Technical Service Bulletin

94 Rear side marker light inoperative in lower rear bumper (DTC 02911, 02912)

94 14 37 2029782/3 April 7, 2014. Supersedes Technical Service Bulletin Group 94 number 12-95 dated October 25, 2012 for reasons listed below.

Model(s)	Year	VIN Range	Vehicle-Specific Equipment
Q5	2010 - 2013	All	Not Applicable

Figure 2. Taillight lens separation.

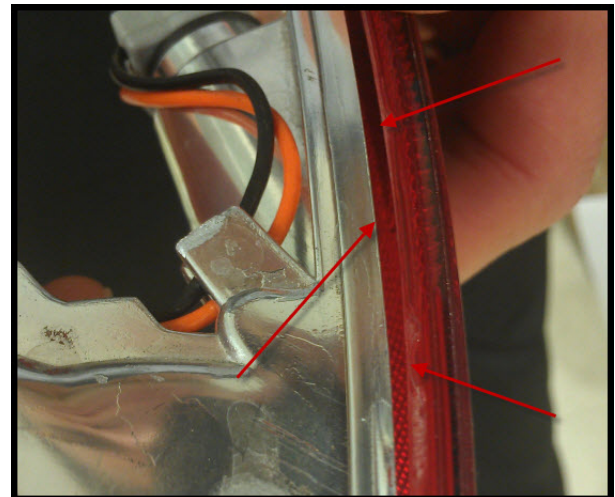
1. Before proceeding, visually inspect both lower taillight housings on the vehicle to ensure there is no damage due to outside influence. If damage due to outside influence is found, do not proceed with this bulletin.
2. Uninstall both lower rear taillight housings.
3. Inspect the lens for any separation around the red reflecting edge of the taillight lens (Figure 2). Areas of the seam that have separated will appear more opaque and be a different shade of red than the rest of the seam.

4. If any separation is found, replace the complete taillight housing.
Re-use any good bulbs and wiring; only replace burnt-out bulbs. Wipe the bulbs with alcohol before installing, and ensure that they are free of any dirt, grease, oil from hands, etc.
5. Inspect the bulb holders for corrosion and debris. Repair and clean as necessary.
